ARCHITECT'S SUPPLEMENTAL INSTRUCTIONS

PROJECT:	Lee Lofts II – Tenant Space 2 Offices Salina, Kansas	Report No.	One (1)
OWNER:	Overland Property Group Dan Maximuk 234 N. Santa Fe Ave, Suite A Salina, KS 67401	Date	Oct. 14, 2024
CONTRACTOR:	MCP Group 3501 SW Fairlawn Rd. Topeka, KS 66614	Architect's Proj No.	24-3420
		Contract For:	General Construction Mechanical, Electrical

E1.1
 COPYRIGHTED

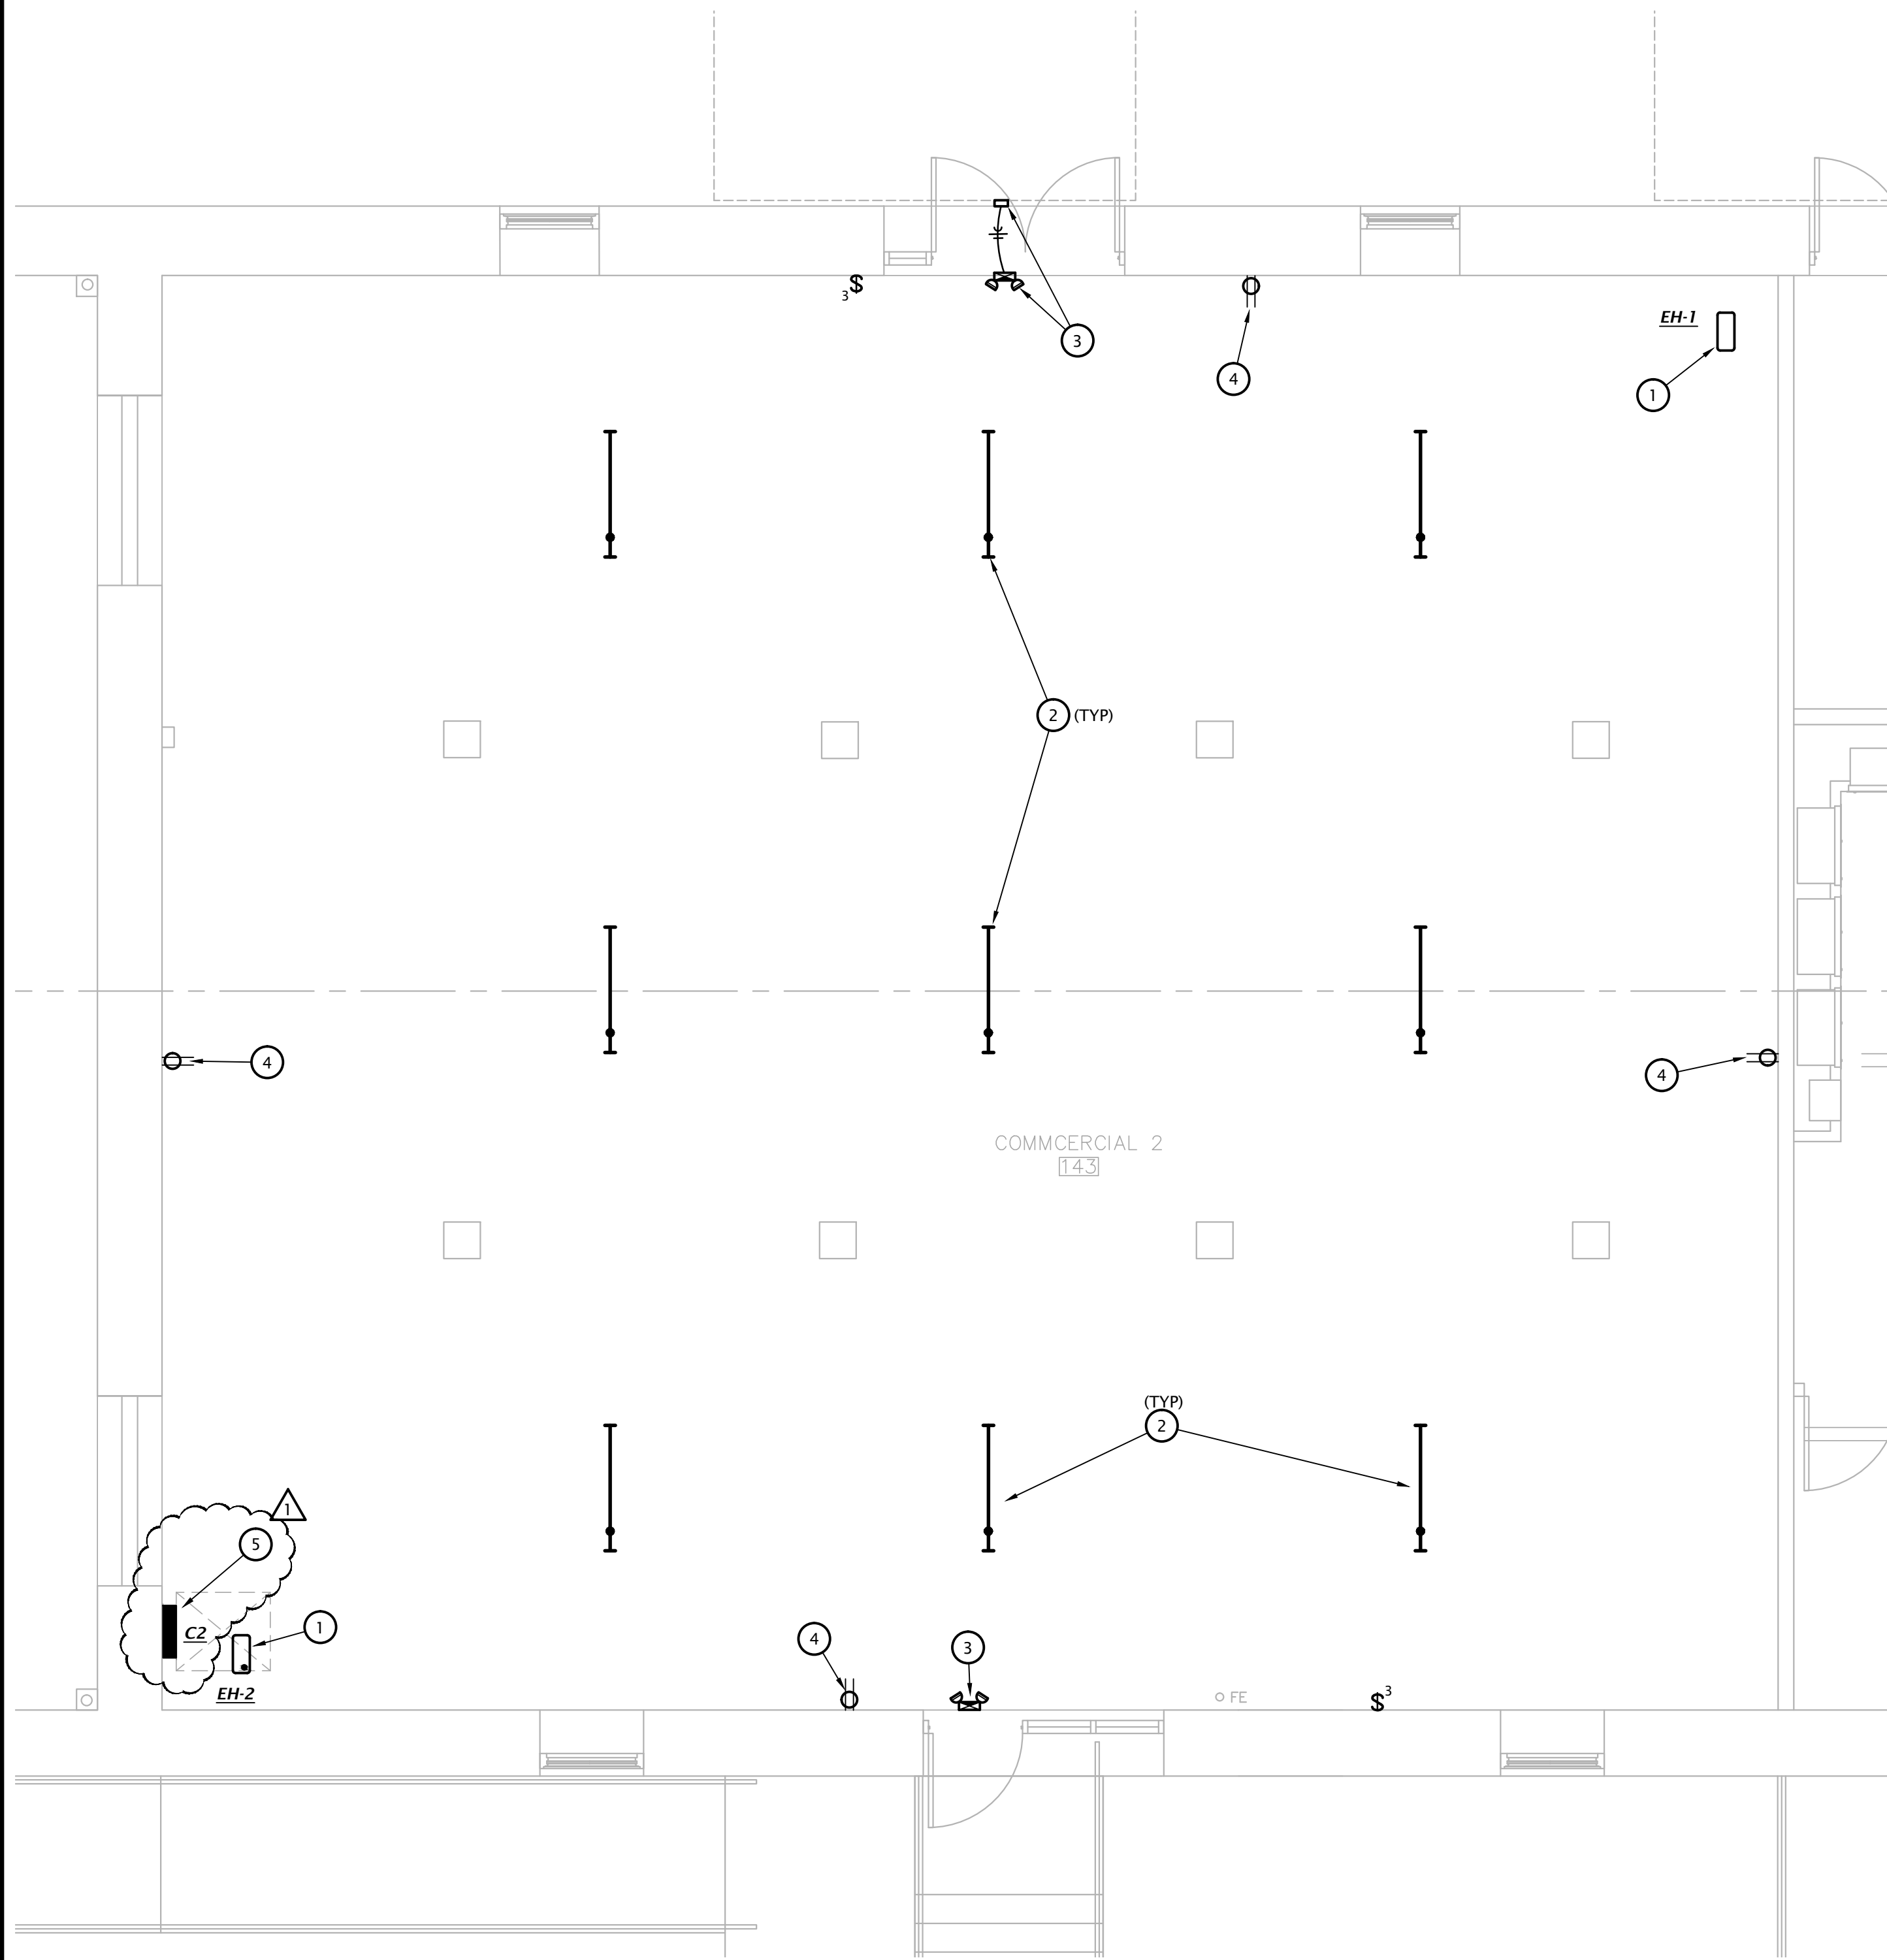
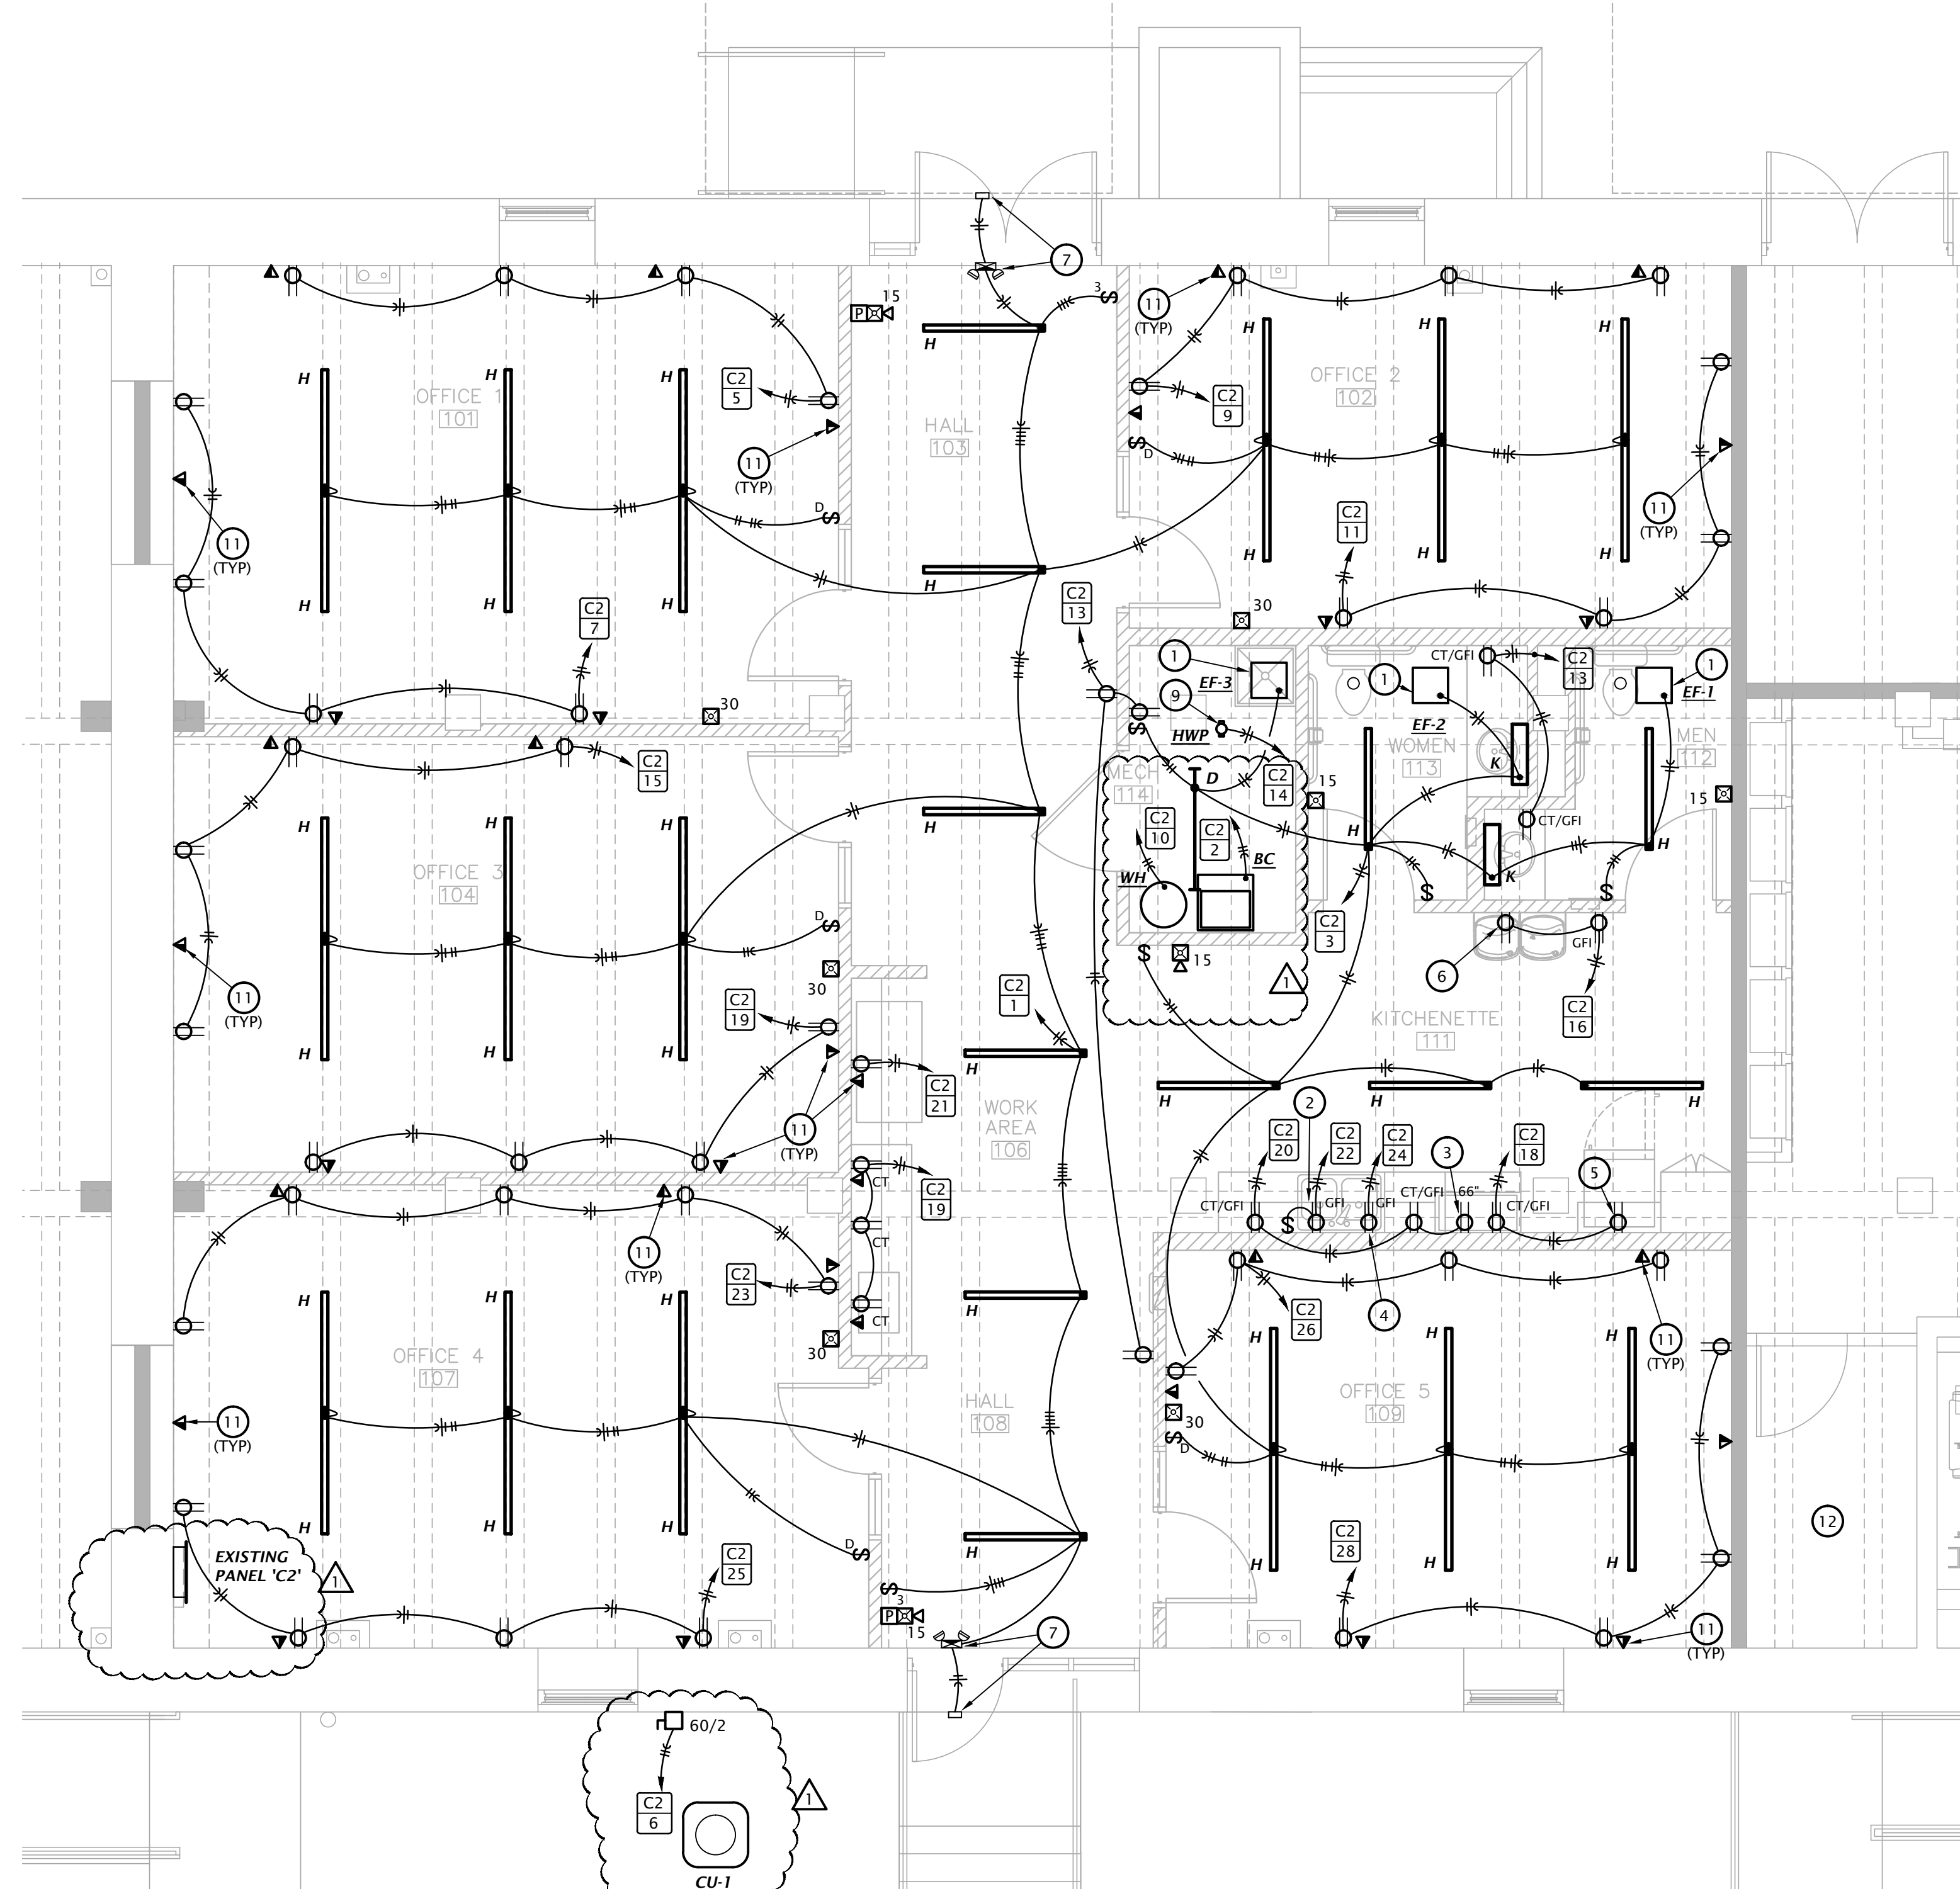
- e. Sheet M1.2 and M1.3 – revised for modification to mechanical closet size and electrical panel is to remain in existing location.
 - f. Sheet E1.1 – revised to show condensing unit to grade, modifications to mechanical closet size and show existing panel 'C2' as existing to remain.

- REMOVE ELECTRIC HEATER AND ALL ASSOCIATED INSTALLATION FROM PROJECT AREA.
- REMOVE EXISTING LIGHT FIXTURES AND ALL ASSOCIATED ELECTRICAL INSTALLATION FROM PROJECT AREA.
- EXISTING EXIT/ EMERGENCY LIGHTS TO REMAIN. MODIFY EXISTING CIRCUITRY AS REQUIRED. SEE NEW WORK PLAN FOR ADDITIONAL INFO.
- REMOVE ALL EXISTING RECEPTACLES AND ASSOCIATED ELECTRICAL INSTALLATION FROM PROJECT AREA.
- EXISTING PANEL 'C2' TO REMAIN.
